**A RESOLUTION ON THE PROPOSED MODIFICATIONS  
TO SMITH LEVEL ROAD**

Resolution No. 43/2002-03

SUBJECT: Project 9.8070219 (U-2803) Orange County  
Carrboro - SR 1919 (Smith Level Road) from Rock Haven Road to  
Bridge No. 88 over Morgan Creek

Interim Post Public Hearing Response

## TYPICAL SECTION 4-LANE DIVIDED

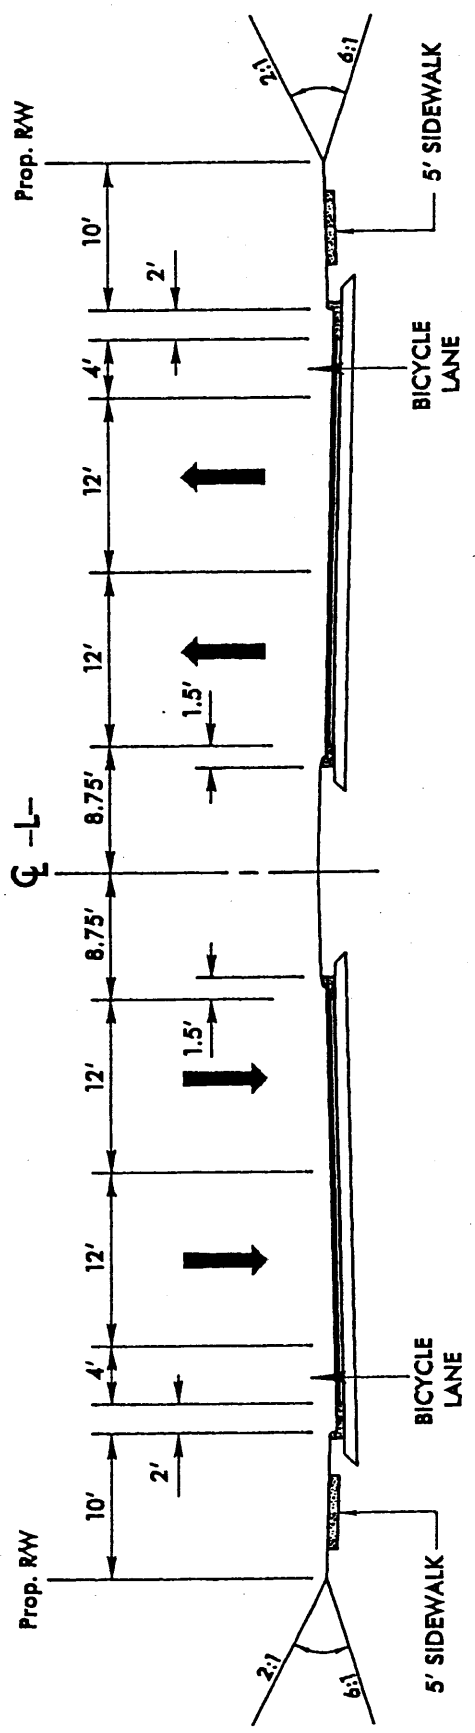
Many citizens are concerned that the widened roadway will remove existing buffers between Smith Level Road and adjacent residential properties. Citizens have suggested that a two-lane or three-lane facility, with sidewalks and bike lanes on both sides, would improve the safety and function of Smith Level Road while maintaining buffers along the roadway.

Due to citizen interest, the Carrboro Board of Aldermen asks that NCDOT re-evaluate its position by studying the benefits of a two-lane or three-lane cross-section with bike lanes and sidewalks on both sides. As part of this re-evaluation, the Board of Aldermen requests that

Mr. Dito does not want the buffer of trees along Smith Level Road adjacent to the Berry Hill Subdivision to be disturbed. Closing the median at Willow Oak Lane would force traffic through the entire length of the subdivision creating safety problems for the children. This would also force all traffic through the signal at BPW Club Road. Mr. Dito agrees with sidewalks but would like the speed limit dropped to 35 mph.

Mr. Walsh stated that a 3-lane section would serve the needs of the area. Access across the median must remain open at Willow Oak Lane. Signals must be timed at NC 54 and Smith Level Road to better facilitate traffic flow through the area. The main problem on Smith Level Road is the entrance and exit to Frank Porter Graham Elementary School. A study of the NC 54 interchange area may yield better traffic flow without adding lanes south of Morgan Creek Bridge.

Due to citizens requests, the Board of Alderman for the Town of Carrboro requests that NCDOT re-evaluate a 2- or 3- lane typical section including sidewalks and bike lanes. The evaluation should include innovative intersection design to improve operations and reduce the need for a four-lane divided section. The Board asks that NCDOT re-evaluate the projected traffic volumes to ensure that Smith Level Road is kept a route that serves local traffic and that the newly widened US 15-501 is the primary route for UNC-RTP traffic. NCDOT should review the NC 54 interchange area just north of the project termini to determine if any recommendations could be made to improve congestion within the interchange.

- 1) **Issue:** Reduce typical section to two or three lane and provide median openings at Oak Spring Court and Willow Oak Lane.

**Action:** Rhett Fussell (NCDOT, Statewide Planning) confirmed that the recent widening of US 15-501 was incorporated into the original traffic model. He will review all the original traffic counts and turning movements on Smith Level Road used for the public hearing. NCDOT will gather additional traffic counts from all access points to the Berryhill Subdivision and the Village Apartments. Projected traffic volumes will be remodeled using different design speeds and typical sections to determine the proposed improvements. DOT will then review the revised traffic counts and modeling with the Town of Carrboro.
